## KEEP IT GREEN 2014

### COMMENTS ON MU1: REVISED PLANS FOR 2021/1089 AND 2021/1090

Section on 5 Colster Close. See Appendix A

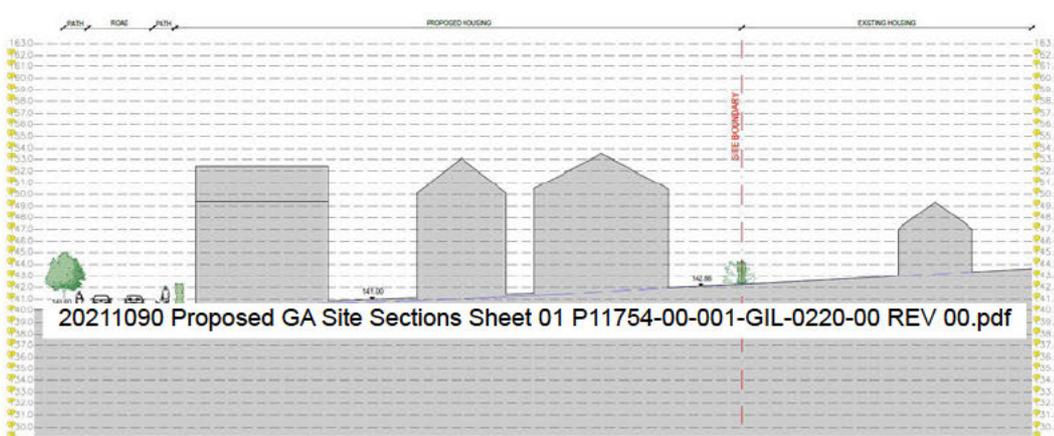
LEVELS BASED ON 20211090 Masterplan Proposed Regrade Contours Sheet 2 QD2088-00-301.pdf  
 DISTANCES BASED ON 20211090 ES Appendix 10.11 -Geoenvironmental Appraisal - Pogmoor\_Part1of4.pdf PAGE 105

- Houses should be set below the level of existing houses and only proposed on the same level if unavoidable.
- It is strongly recommended that houses sited above the level of existing dwellings should be avoided unless absolutely necessary.
- If this treatment type is unavoidable, adequate buffer planting space should be provided to screen direct views
- Screening/ buffer planting should not detract from either property, or take away considerable usable garden space for the dwelling.
- Proposed dwellings should have adequate flat/ usable garden space and slopes should not fall directly to the building edge.

APPENDIX C

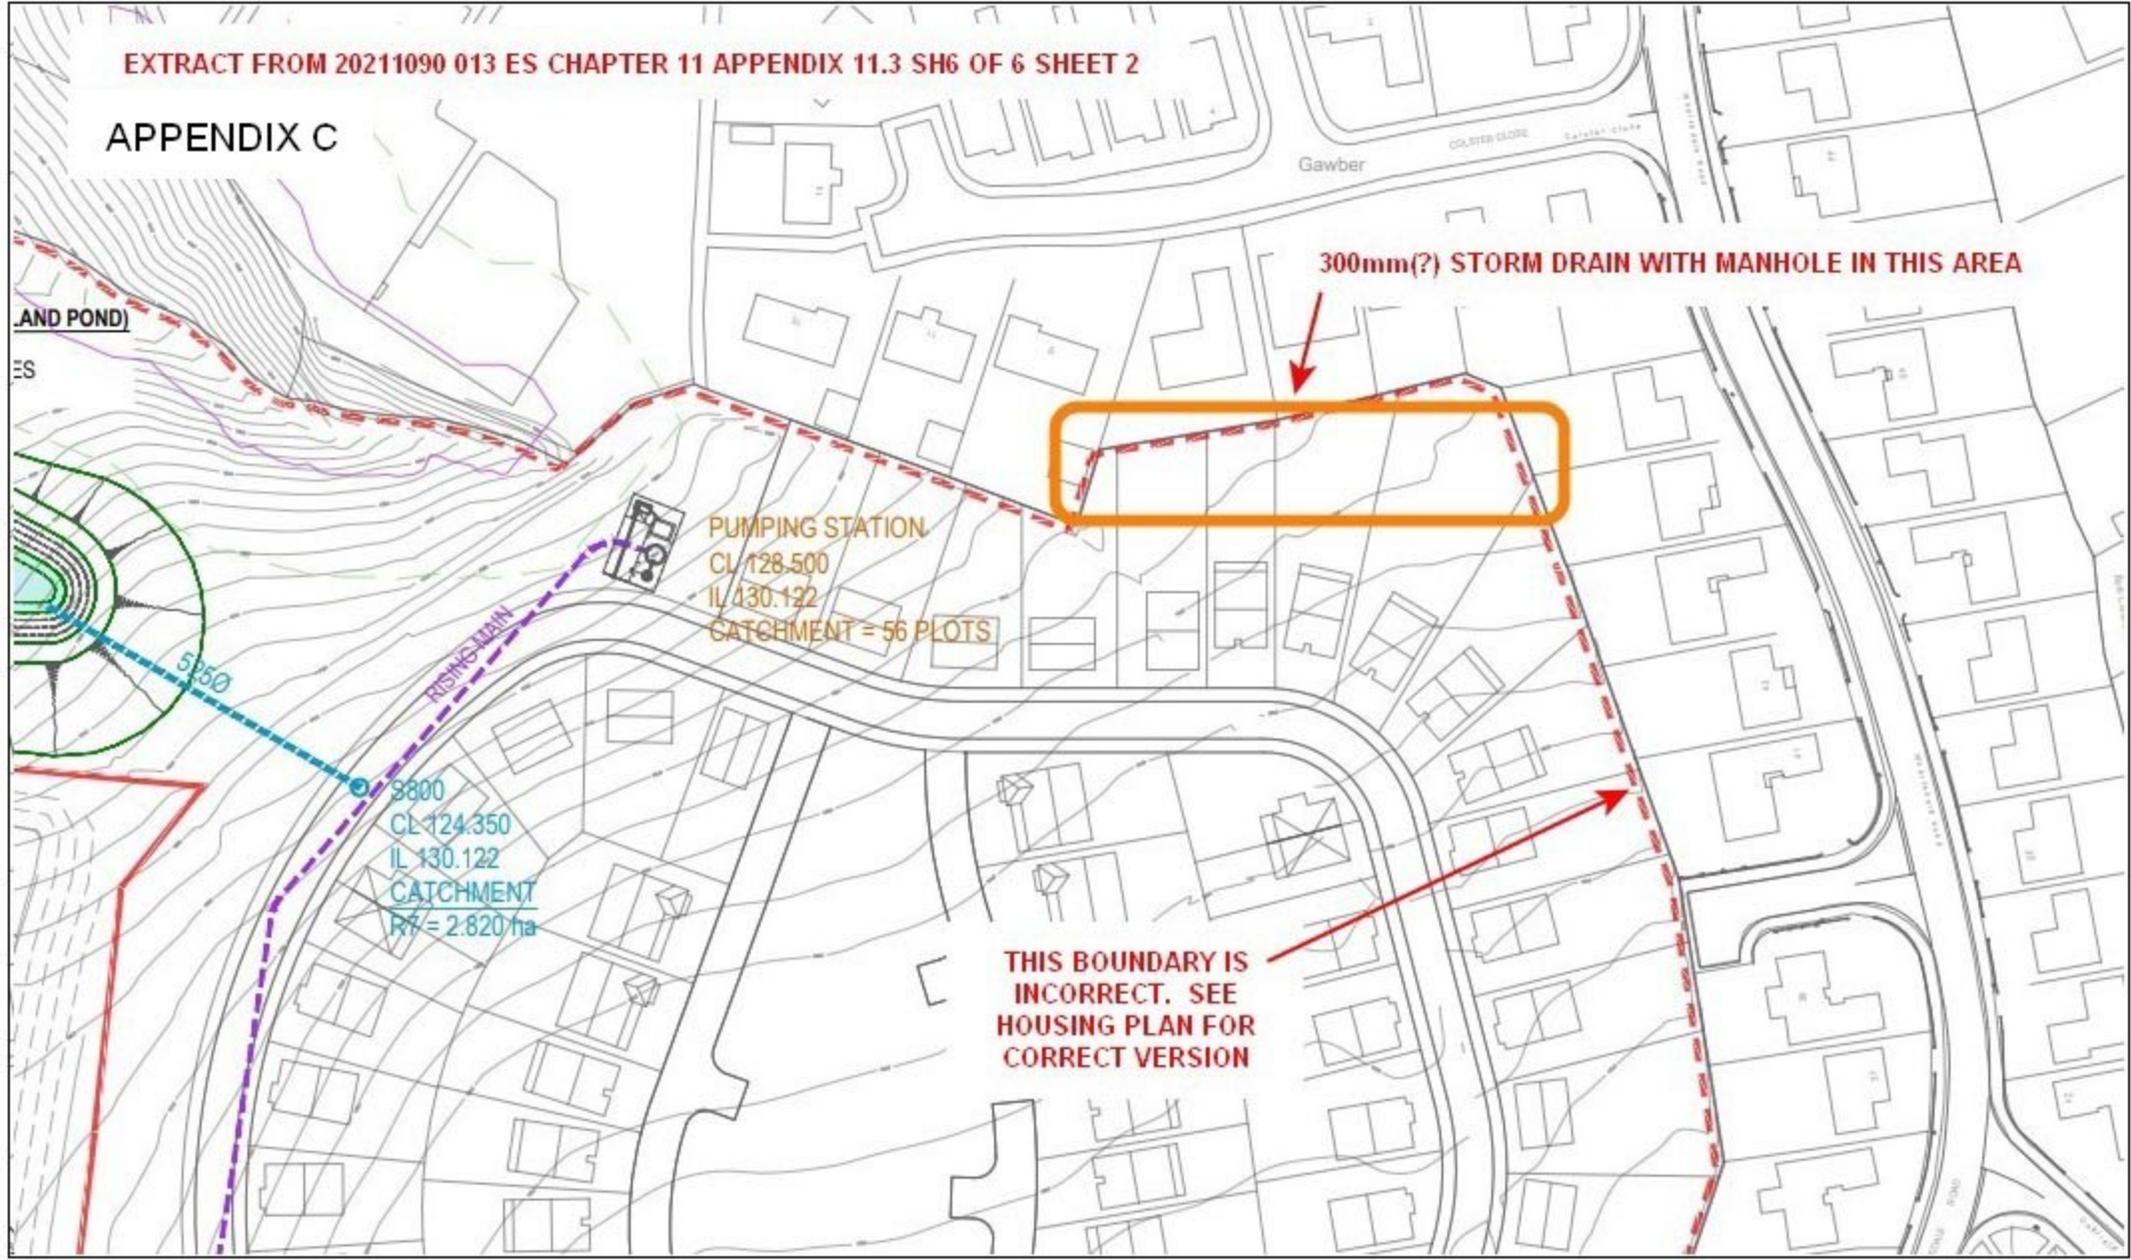
**Appendix C** attached shows a detail from the drainage proposals on plan **20211090 013 ES Chapter 11 Appendix 11.3 - DIA - Resi 6of6.pdf, sheet 2**. There is no reference to the existing (redundant? 300mm diameter?) storm drain, complete with manhole south of No5 Colster Close.

300mm(?) STORM DRAIN WITH MANHOLE IN THIS AREA

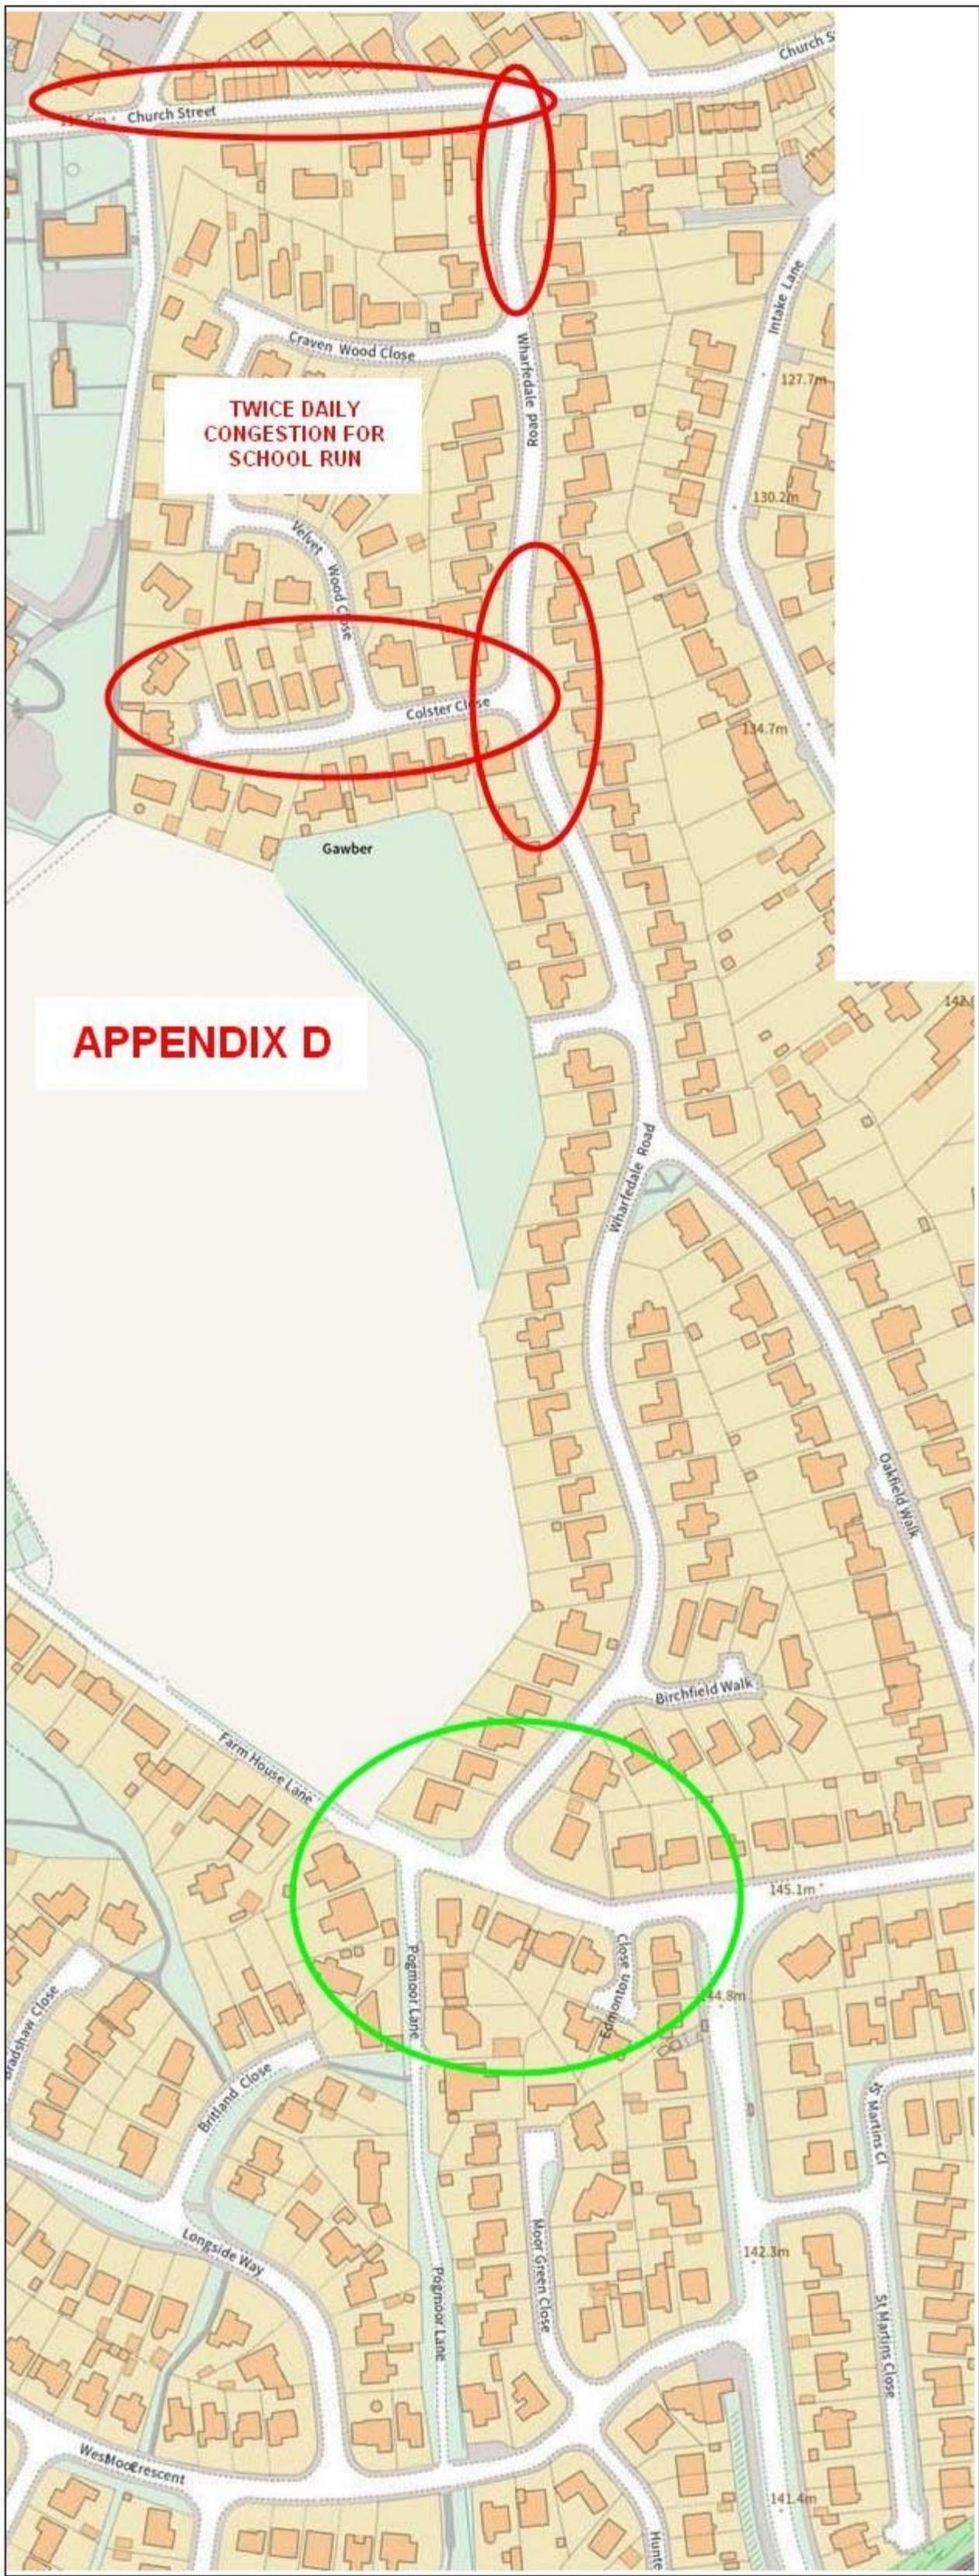
THIS BOUNDARY IS  
INCORRECT. SEE  
HOUSING PLAN FOR  
CORRECT VERSION

**TWICE DAILY  
CONGESTION FOR  
SCHOOL RUN**
